Verification Report

Forest Carbon Partnership Facility (FCPF)

Verification Report (VER)

ER Program Name and Country	Chile Emission Reduction Program
Reporting Period Covered In this Report	01-01-2022 to 31-12-2023
Number of FCPF ERs	3,010,906
Number of ERs allocated to the Uncertainty Buffer	885,558
Number of ERs allocated to the Pooled Reversal Buffer	2,007,268
Number of FCPF ERs from enhanced Removals through afforestation/ reforestation	0
Name of the VVB	AENOR CONFIA S.A.U.
Contact information of the VVB	Génova 6. 28004 Madrid - Spain. Telephone +34 914326000 jfuentes@aenor.com www.aenor.com
Report Version	1.2
Date of the Verification Report	23-02-2026
Report Approved by	José Luis Fuentes

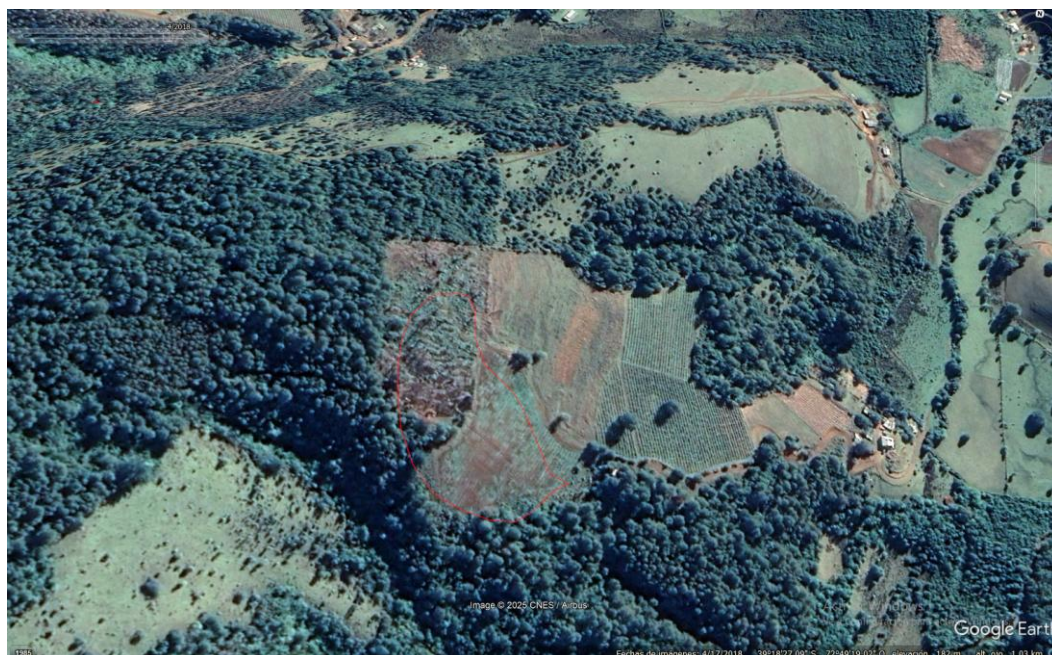
NC ID: Minor	02	Date: 04/11/2025
Description of NC		
<p>The following issues were identified during the uncertainty assessment including collect earth and Monte Carlo:</p> <ol style="list-style-type: none"> 1. The country must explain the overall criteria followed for the following polygons: i) After the AENOR assessment for the plot ID 82272, half of the area is forest (see image below). The VVB requires further explanation on what approach the country is following to report "otros usos permanentes" regarding spreadsheet (Resumen de Muestras_muestreo). ii) Do the same for polygon ID19291 (Araucania_muestreo). 2. The country must explain the lack of certain survey plots within the Google Earth Pro. For example, Muestreo Biobio ID 216321 (see image below), this one appears both within the spreadsheet Respuestas_m2123 Biobio and Resumen muestras 2123_TAB Biobio. The same occurs for plots ID216270 (Biobio); ID217054 (Biobio). Also, for Los Rios ID 44532a; ID52335b and ID52832a. 3. Regarding the Monte Carlo: Clarify the selection of each distribution function for the parameters of native forests. For instance, the selection of distribution functions such as beta, weibull, log-normal, logistica instead of others.

2. To provide additional clarity, it may be helpful to explain the two files referenced in the finding. On the one hand, there is the *Respuestas_m2123_Region* or *Respuestas_pre2123_Region* file, which contains the final responses provided by the interpreters, depending on whether the data correspond to the sampling (m2123) or the presampling (pre_2123).

On the other hand, there is the Resumen_muestras_2123 document, which includes one sheet per region. In these sheets, both samples and presamples are listed (as indicated in column L), along with the land-use change information reported by the map.

Both documents are necessary and essential for calculating the uncertainty by type of change. It is correct that each evaluated point appears in both documents, as one represents the map's classification, while the other represents the interpreter's assessment.

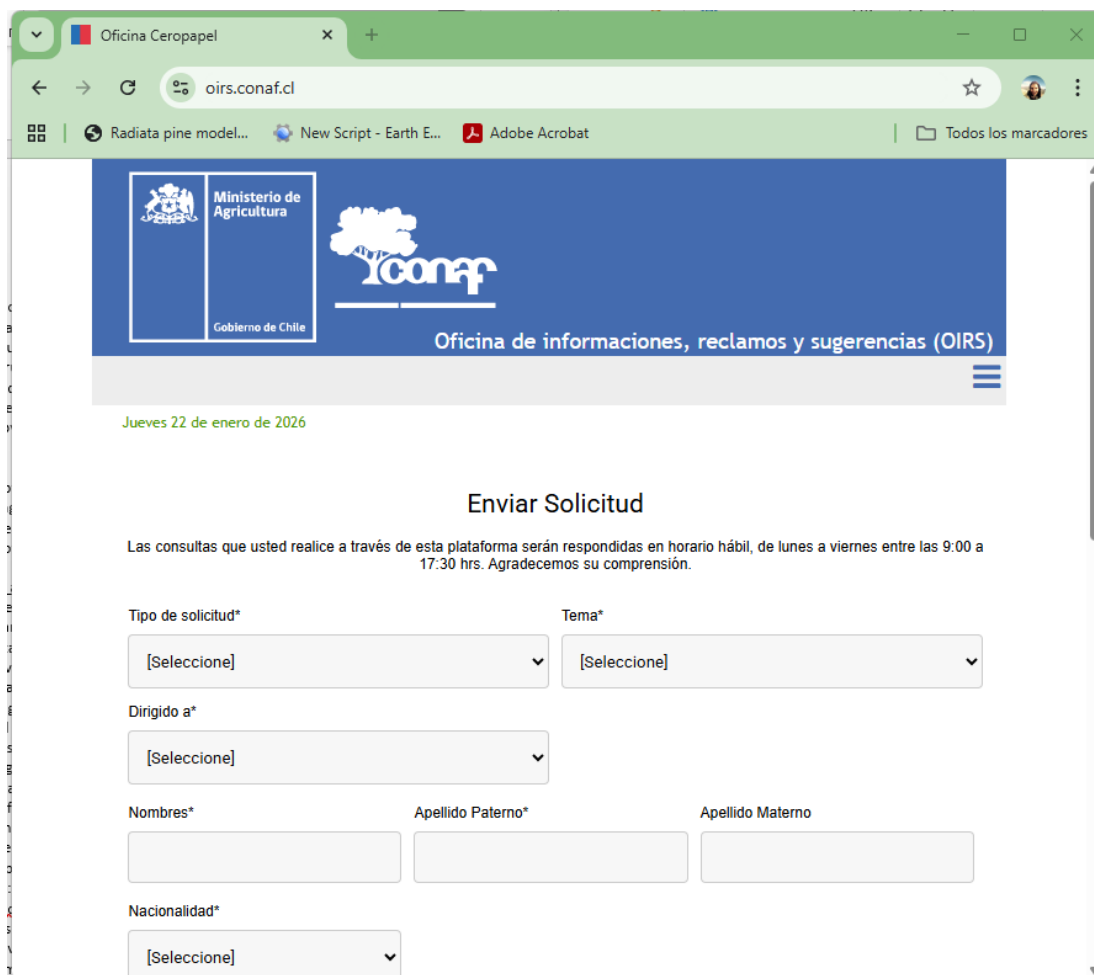
Project Participant response	Date: DD/MM/YYYY
<ol style="list-style-type: none"> 7. There appears to have been an issue with the OIRS CONAF website. Please check it again: https://oirs.conaf.cl/ 	
Documentation provided by the Project participant	
VVB Assessment	
Date: 13/01/2026	
<ol style="list-style-type: none"> 7. Link provided here and in link 60 is not working. How do citizens provide inquiries through this website if it seems that it is not working? Item not closed. <p>Therefore, OBS 06 is not closed.</p>	
Project Participant response	Date: 22/01/2026

The link is actually working in Chile. We have investigated and the reason that the Aenor team could not use the link is because it is not available outside Chile.

With a VPN from Chile is possible open the link.

We provide evidence of the working link:

Documentation provided by the Project participant	
VVB Assessment	Date: 28/01/2026
<p>7. Evidence that the link works properly has been provided and with Country Participant explanations item is considered closed. Therefore, OBS 06 is closed.</p>
